# Rural Irrigation Capital Expenditure Review

Sunwater

Client: Queensland Competition Authority

**AECOM Australia Pty Ltd**

Figure 19 Sunwater’s P3MF - Project Lifecycle and Governance Framework Overview

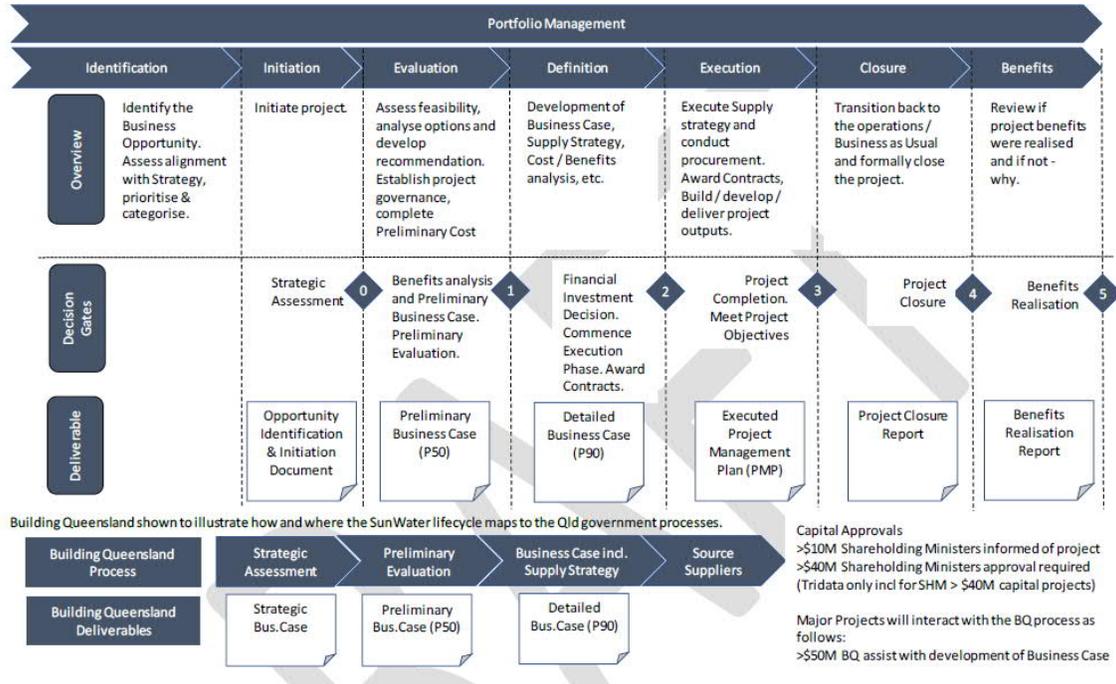
Figure 19 shows an overview of the Project Lifecycle and Governance Framework of the P3MF. Sunwater considers a Project Lifecycle to comprise of seven phases, namely, Identification, Initiation, Evaluation, Definition, Execution, Close out and Benefits. We note that the P3MF while claiming to align with *"A Guide to the Project Management Body of Knowledge, Fifth Edition"* does not give due stress on the Monitoring and Controlling process of the project lifecycle. Review of the sample of projects has brought to light a number of instances where the monitoring and control of the ongoing projects has been found lacking leading to unexplained variations and increase in costs.

Figure 31 Current Condition of Sunwater's Assets Included in the Annuity Submission

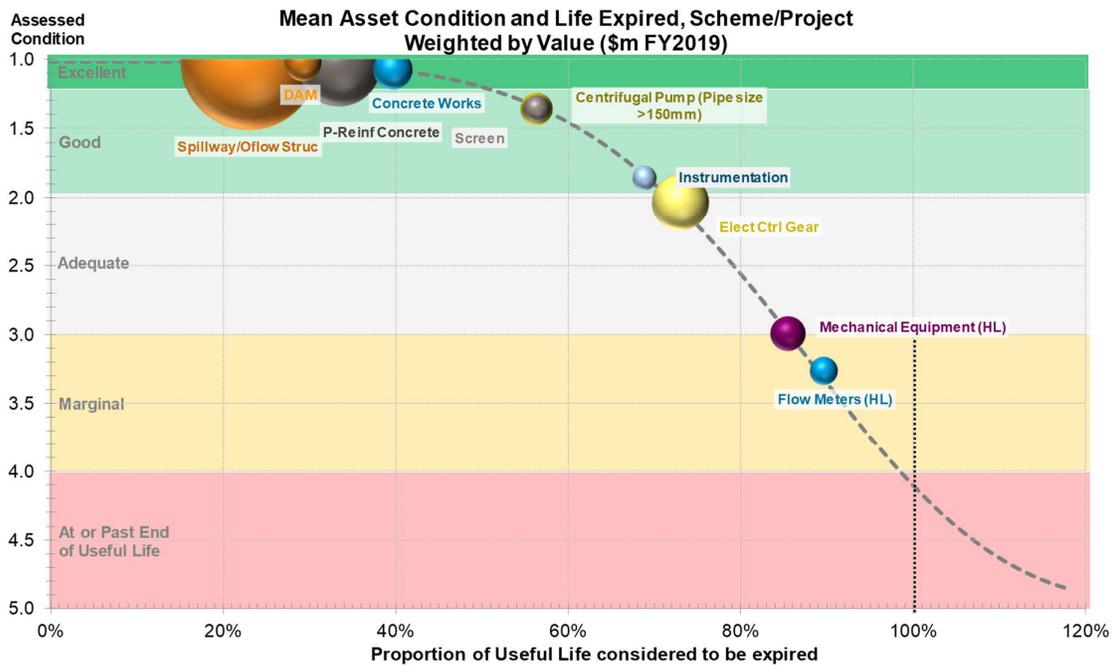
It may be useful to note the current condition of the assets included in Sunwater’s submission. This is shown in Figure 31, which positions Sunwater’s assets according to weighted condition by asset class, where the bubble size indicates the value of each class of assets. The bubbles are presented using the same Weibull curve as used in the previous charts from our model to indicate the approximate stage in their lifecycle.

Figure 32 Current Condition of Sunwater’s Assets in the Annuity Submission Modelled Using Sunwater’s Decay Curve

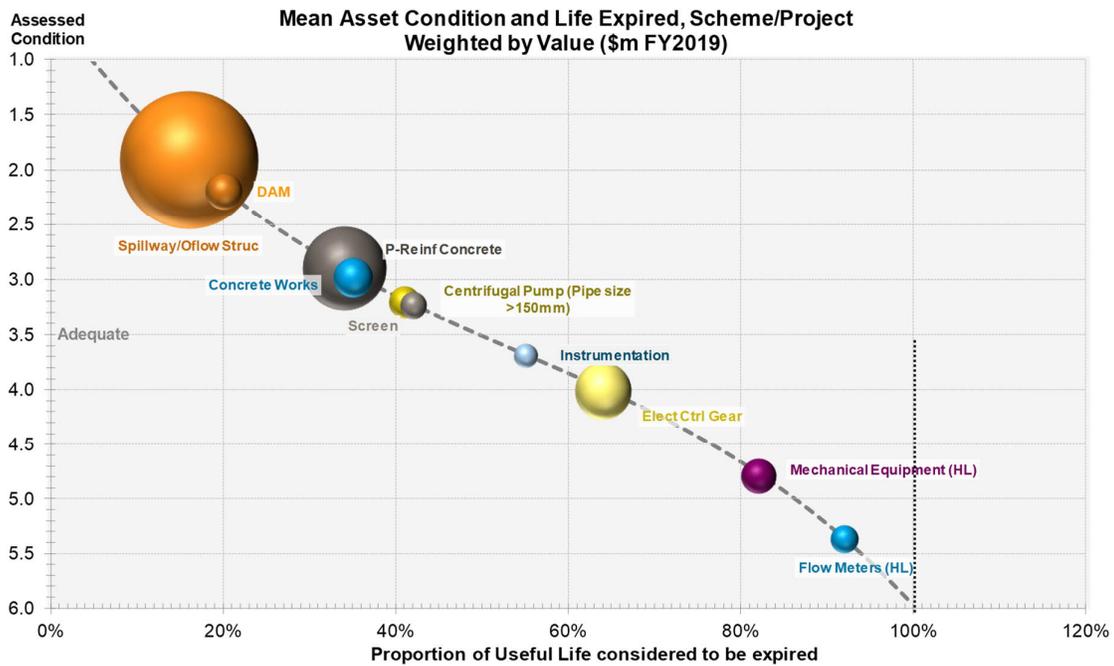
For comparison purposes, the current condition of the assets included in Sunwater's submission is also presented using Sunwater's standard decay curve and Sunwater's condition rating definitions in Figure 32. We note that Sunwater's standard decay curve is notably steeper to the more typical Weibull curve we have employed. We note that both curves assume that asset failures will follow a similar distribution (which is unlikely to be the case in practice).

Figure 33 Revised Forward Renewal Program Applying a 10% Increase in Useful Life (\$ million, FY19)

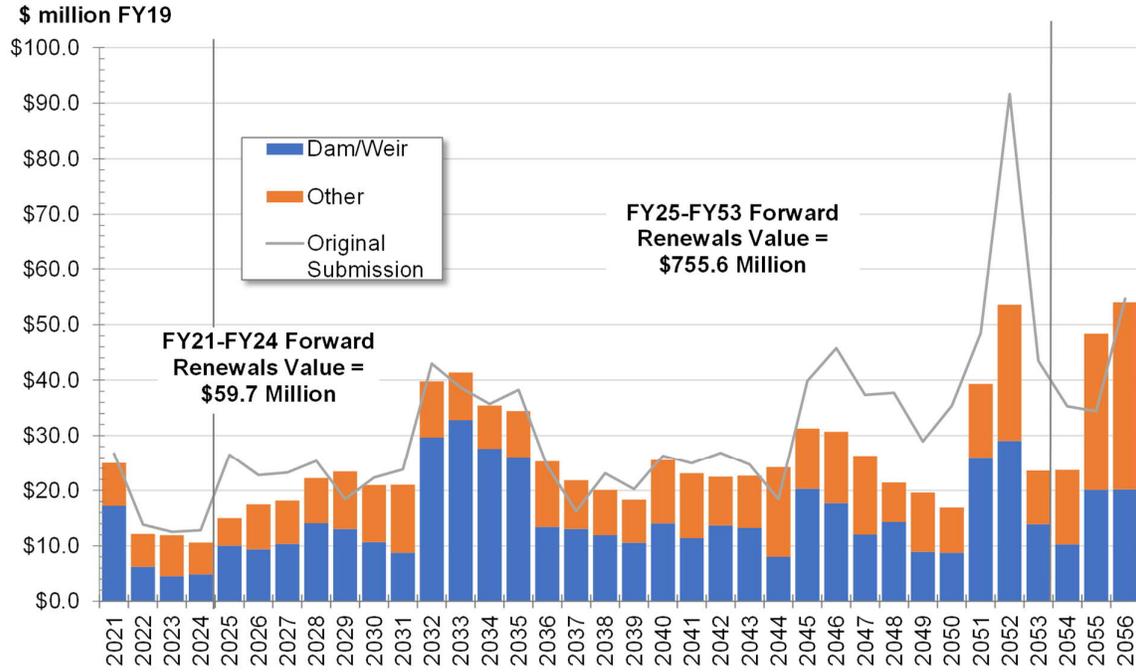
As indicated in Figure 33, the value of the annuity reduces to \$59.7 million and \$755.6 million for the price path period and beyond price path period respectively. As indicated in Figure 34, the annuity value is sensitive to asset life expectancies.

- We recommend that our revision of Sunwater's data as indicated in Figure 33 be used for calculating the annuity. This would reduce the value of the annuity to \$59.7 million and \$755.6 million for the price path period and beyond price path period respectively (in \$FY19). This adjustment is primarily a prudence adjustment to account for overly-conservative renewals timing.

Figure 37 Revised Renewal Program Applying Sunwater's Rules (\$ million, FY19)

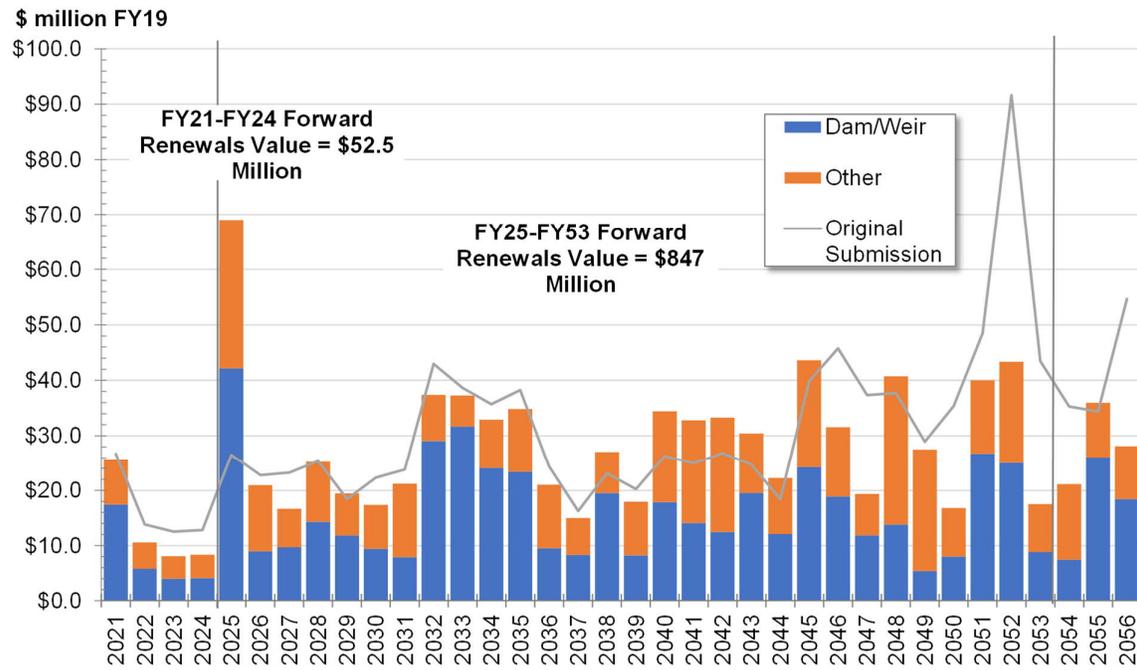
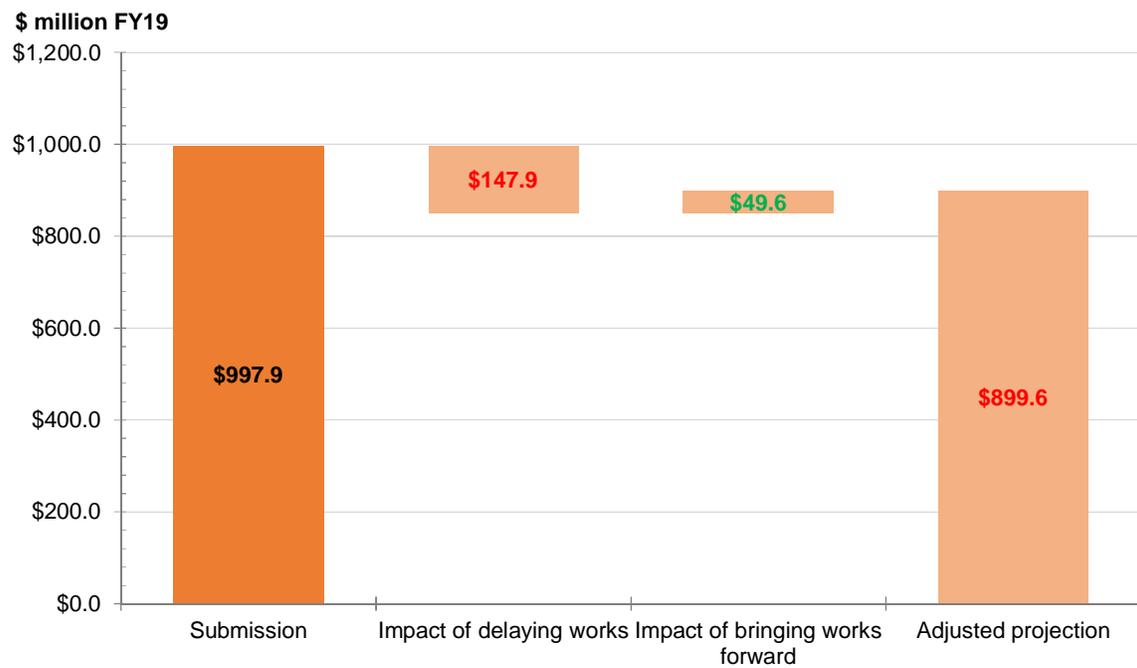
We have applied Sunwater’s rules to the proposed renewal projects as we believe they should have been applied, following Sunwater’s own documented procedures. The result is shown in Figure 37, with Sunwater’s revised submission shown as a line above the bars. A breakdown of the adjustments made due to the timing of projects is presented in Figure 38.

The revision reduces the value of the annuity to \$52.5 million and \$847.0 million for the price path period and beyond price path period respectively (in \$FY19). This finding is in support of the adjustment made in Section 7.4.2, indicating that Sunwater’s renewals program as submitted would result in over-maintenance of assets. This adjustment based on projected condition is shown for indicative purposes only, and is considered to be captured by the adjustment made in Section 7.4.2 reflecting an increase in useful life.
